RANDAL PARK PHASES 2-5

Specific Parcel Master Plan (SPMP) approval for Phases 2,3,4 and 5 of the Randal Park residential development. The project is comprised of 558 residential units with 4 different lot types including 335 detached single family units and 223 townhome units.

Addendum:

This addendum is to revise the Transportation Engineering comments for MPL2013-00002.

DEVELOPMENT PLAN—PHASE 3

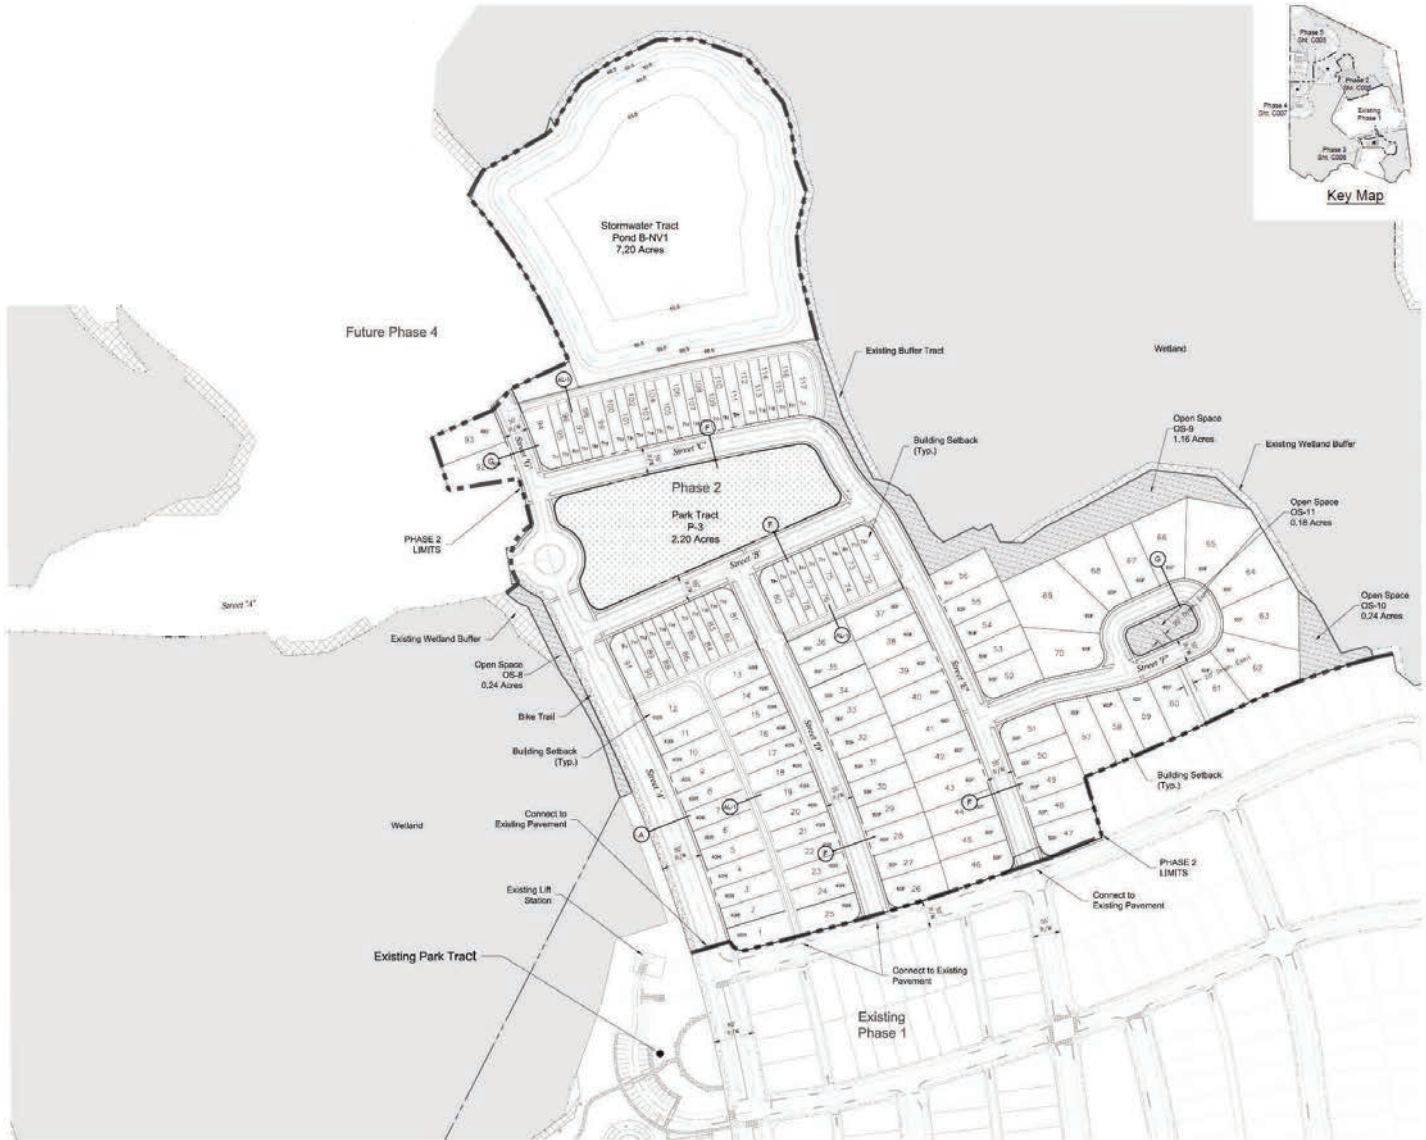
- ~~The intersection of "Street I" at "Street H" near the school site shall align with the school driveway.~~
- ~~The alley for lots 122-131 shall be one-way SB to prevent vehicles from entering the alley so close to Randal Park Blvd.~~

- Where "Street I" intersects "Street H" across from the elementary school property, a raised, triangular island shall be constructed to prohibit southbound left turns onto "Street H" and the sidewalk on the north side of "Street H" shall be realigned so the walking path avoids the raised island.

- The uncontrolled crosswalk on "Street H" east of the school driveway shall be relocated east of and outside the alleyway curb cut.
- There shall be a signed no parking zone on both sides of "Street H" adjacent to the elementary school property and on the west side of "Street H" adjacent to the open space.

- The alleyways serving lots 118-130 and lots 131-152 shall be one-way southbound and one-way northbound, respectively.

- The intersection of "Street I" at "Street H" near the school site shall align with the school driveway.
- The alley for lots 122-131 shall be one-way SB to prevent vehicles from entering the alley so close to Randal Park Blvd.

TYPICAL ROAD CROSS SECTIONS

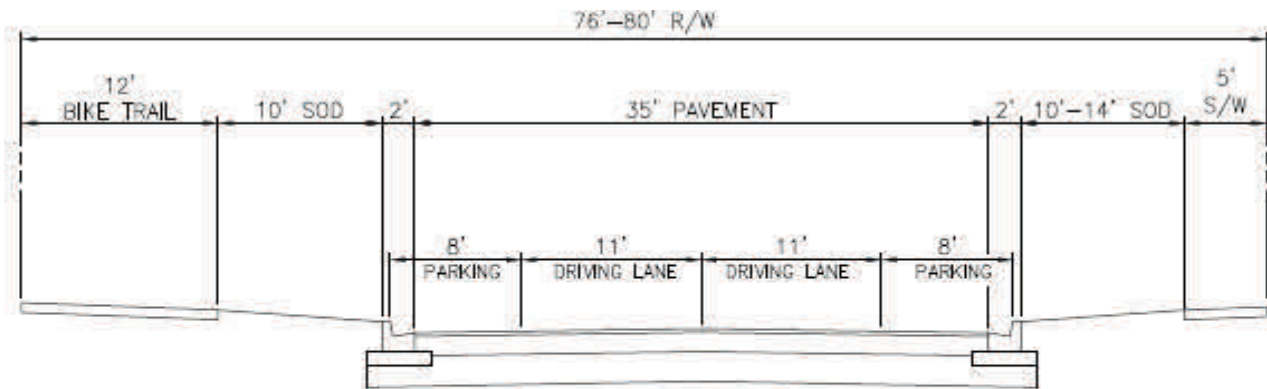
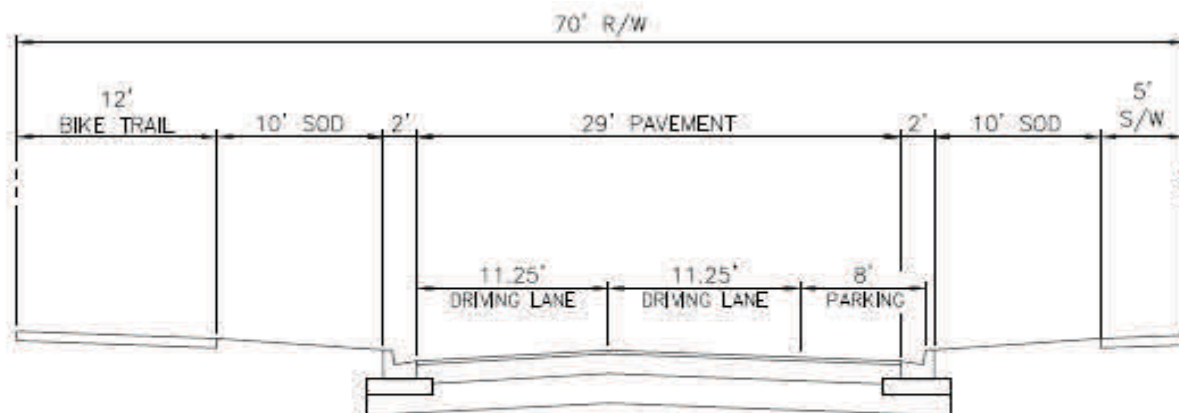
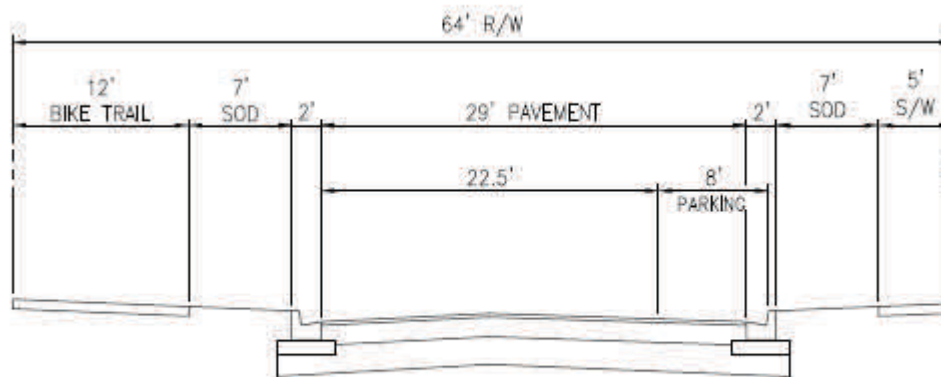
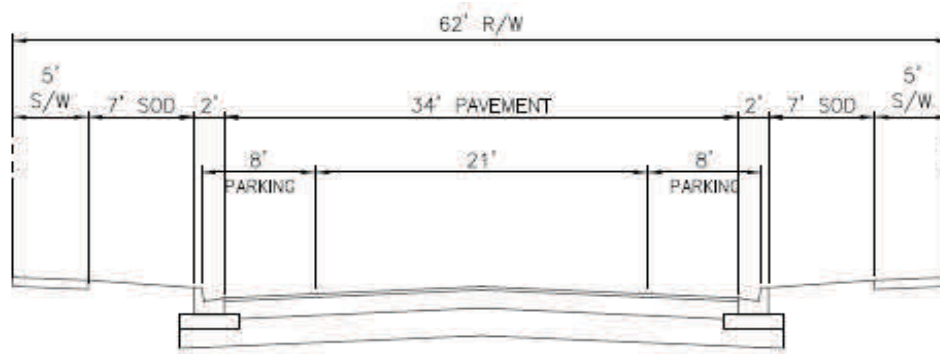
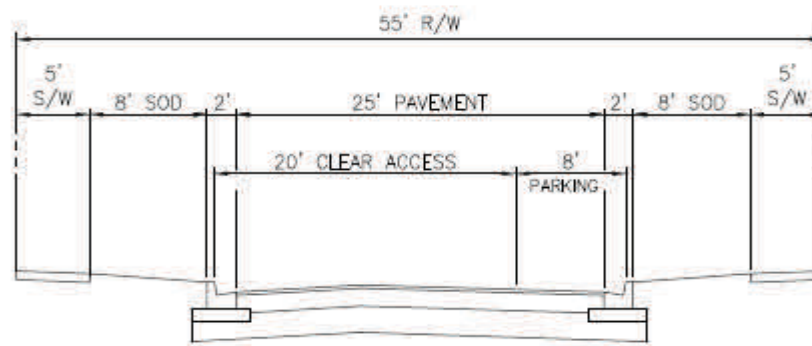
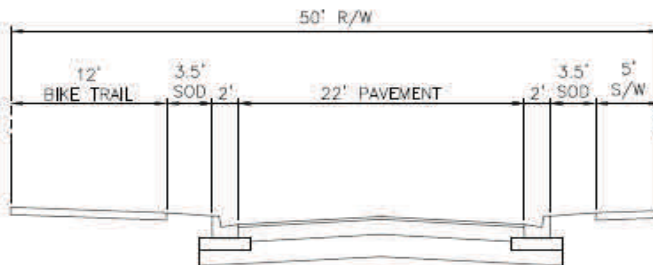
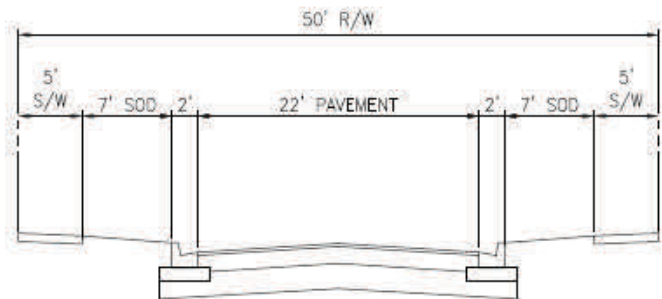
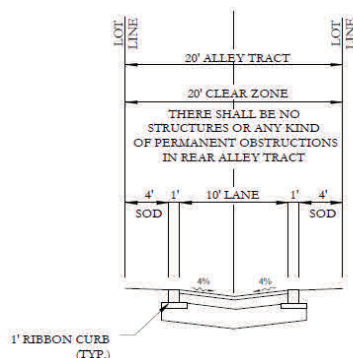
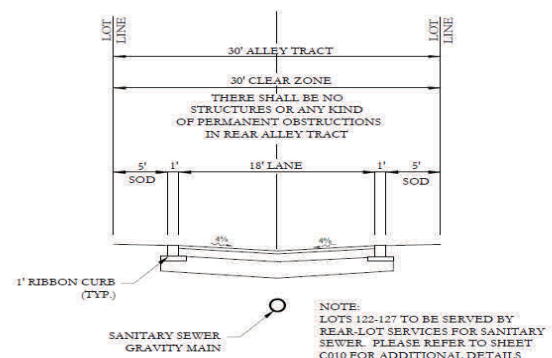
- The gutter pan shall not be included in the width of any traveled way.
- ~~At the most, only 1' of the gutter pan shall be accounted for when measuring parking stall/lane widths. Do not measure from the face of the curb.~~

- Marked parking lanes or parking stalls shall be at least 8' wide.
- Are the parking lanes on Typical Sections B, D, E, & F to be marked? If not, will parking be allowed on both sides? If not, "No Parking" signs shall be installed by the developer according to City Sign Shop specifications.

- Is parking allowed on Typical Sections C & G? If not, "No Parking" signs shall be installed by the developer according to City Sign Shop specifications.

- Any roadway with an asphalt width less than 24' shall have parking restricted on at least one side through the use of "No Parking" signs.
- What is the clear zone between the trail and the drop-off in Typical Section J?

- Since the alleys have center drainage, consider the use of a center concrete gutter.

- The gutter pan shall not be included in the width of any traveled way.
- At the most, only 1' of the gutter pan shall be accounted for when measuring parking stall/lane widths. Do not measure from the face of the curb.

- Marked parking lanes or parking stalls shall be at least 8' wide.
- Are the parking lanes on Typical Sections B, D, E, & F to be marked? If not, will parking be allowed on both sides? If not, "No Parking" signs shall be installed by the developer according to City Sign Shop specifications.

- Is parking allowed on Typical Sections C & G? If not, "No Parking" signs shall be installed by the developer according to City Sign Shop specifications.

- Any roadway with an asphalt width less than 24' shall have parking restricted on at least one side through the use of "No Parking" signs.
- What is the clear zone between the trail and the drop-off in Typical Section J?

- Since the alleys have center drainage, consider the use of a center concrete gutter.
